# Hardware Review Report

Version 1.0
Espressif Systems
Copyright © 2023

## 1.3. Clock

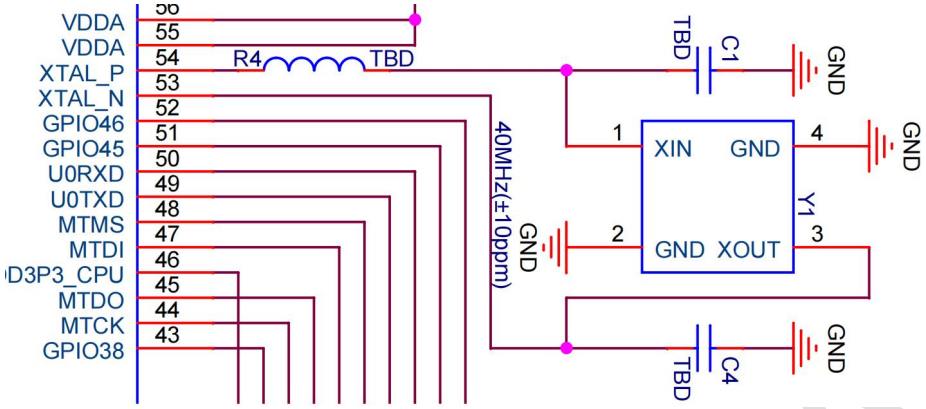
a. Please add a series component at XTAL_P line, then use a 24 nH inductor as initial value for this series component.

b. Please be noted that the final values of series inductor and parallel caps should be obtained after RF tuning process.

c. Please be noted the precision of 40 MHz should be at least 10 ppm.

## 1.4. Reset/Enable

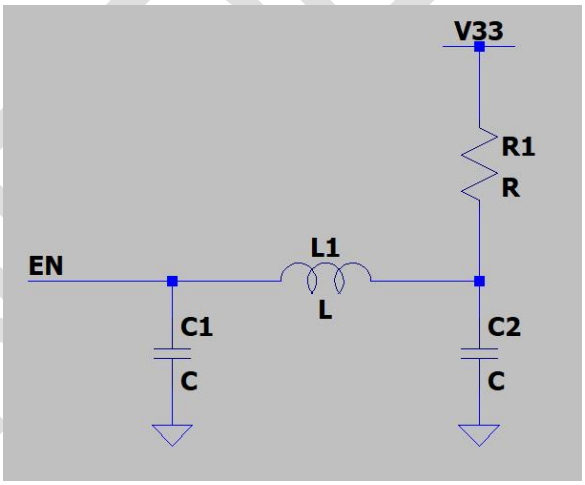
a. Please be noted that RC at CHIP_PU pin should be adjusted with real power to meet the requirements of power-up and power-up sequence.

b. If space is allowed, it is suggested to reserve another CL close to CHIP_PU pin to improve EMC performance. Initially, do not stuff for C1 and use 0 ohm resistor for L1

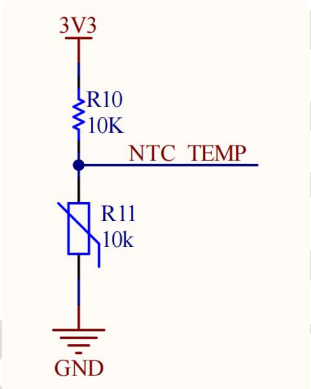
b. If space is allowed, it is suggested to reserve a CL close to GPIO0 pin to improve EMC performance. Initially, do not stuff for C1 and use 0 ohm resistor for L1.

## 1.8. Flash/PSRAM

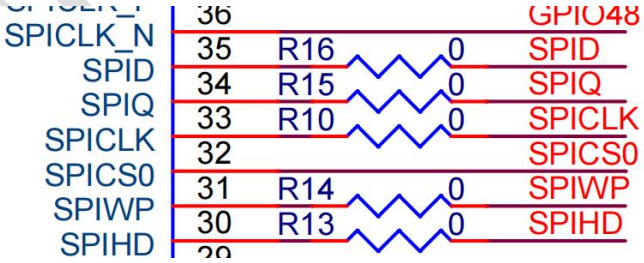
a. It is recommended to add a zero-ohm series resistor on the SPI communication lines for future adjustment.

## 2.1. PCB Check

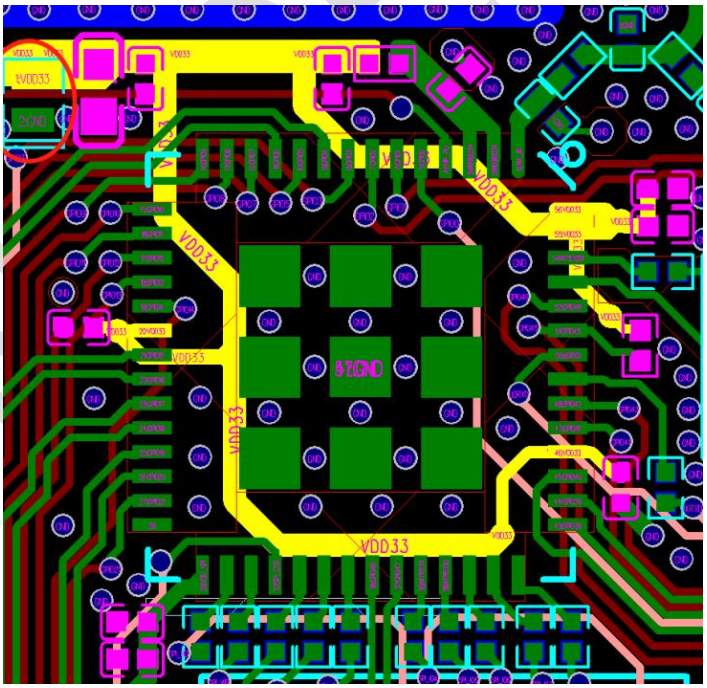
a. FR4 material is recommended for PCB layout.

b. It is recommended to use 4 or more layer design.

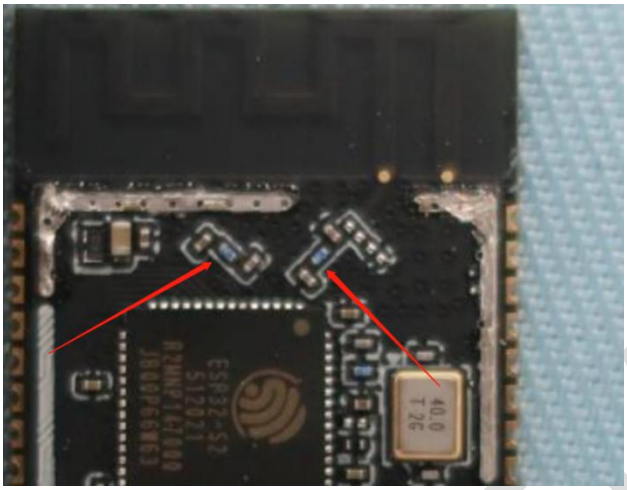
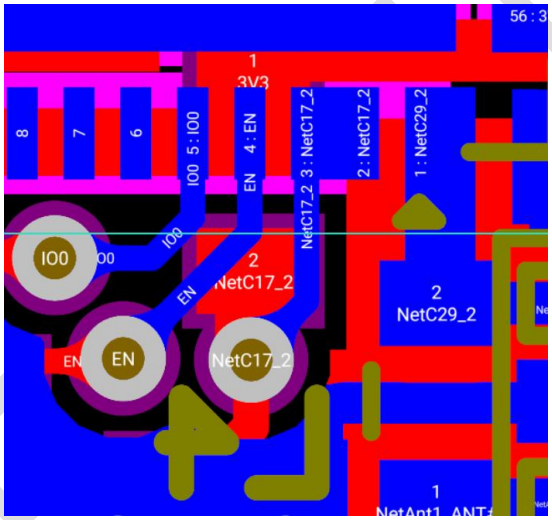
c. It is recommended to use 0201 package for capacitors of 1 uF and below, and then place the capacitors as close to the power pins as possible. Especially pins 2 and 3, the corresponding filter circuit needs to be as close to this pin as possible. You can refer to the figure below for this part. The power traces of pins 2 and 3 are routed at a 45° angle to the pins, and the RF traces next to them are routed at a 45° angle to the other side. In this way, the distance between the power supply and the RF can be as wide as possible, and the related circuits can be placed close to their respective pins.

d. Please do not add via on pins 2 and 3 traces.

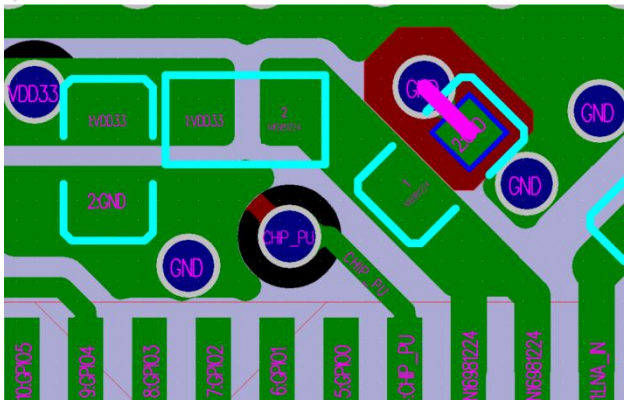
e. All power supplies, especially pins 2 and 3, must be adequately grounded and surrounded by dense ground holes, so that the harmonic suppression effect is better.

f. In the circuit of pins 2 and 3, you can add a via on the first capacitor through other layers to the bottom layer, which can further suppress harmonic interference.

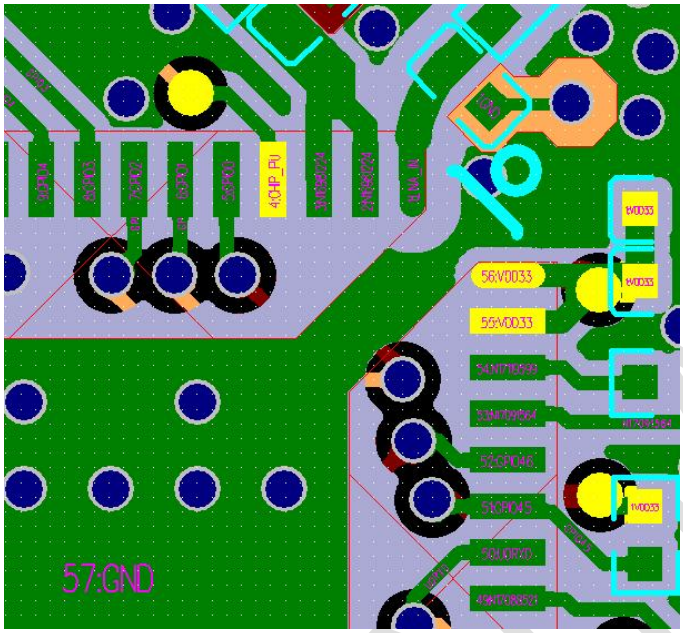
g. It is suggested to connect S3 EPAD to external ground through traces or copper.

## 2.3. RF

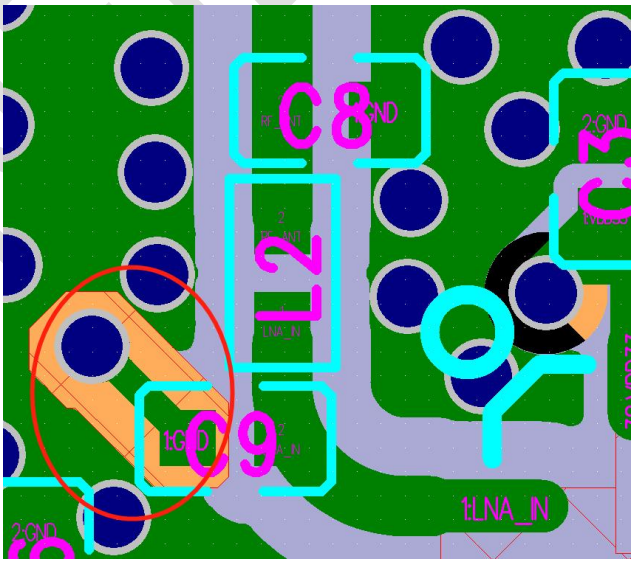
a. Please be noted that all RF traces should have 50 ohms impedance control in process.

b. Please use the 0201 package for CLC matching and place it as close to the chip pins as possible. The matching circuit is placed in a Z-shape, that is, the two capacitors should not face the same direction. Then please add a small stub at the first capacitor (close to the chip) to suppress harmonics. The length of the stub is 15 mil, the via is drilled to the third layer, and the impedance is approximately 100 Ω ± 10%.

c. There is too little ground for RF on the current layout, please improve this point, to make sure RF traces are surrounded by enough ground and dense via.

## 2.4. Clock

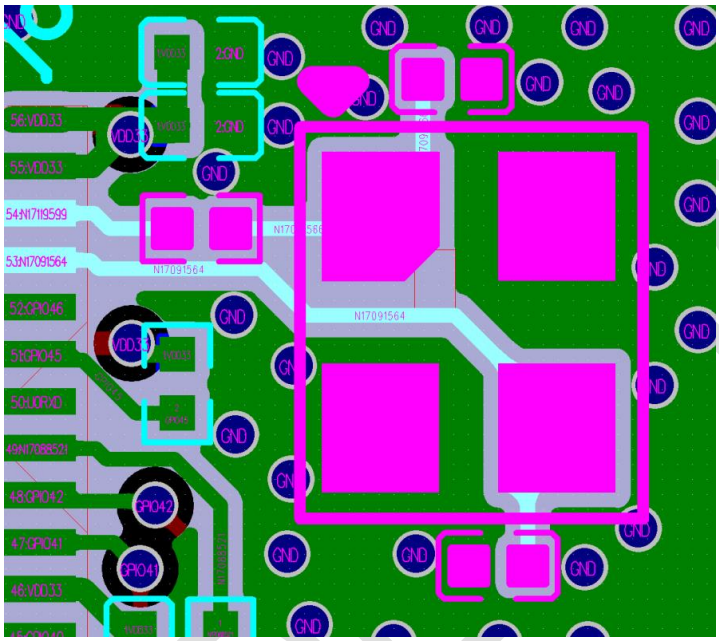
a. There is too little ground for crystal part. Please improve crystal part referring to the figure below:
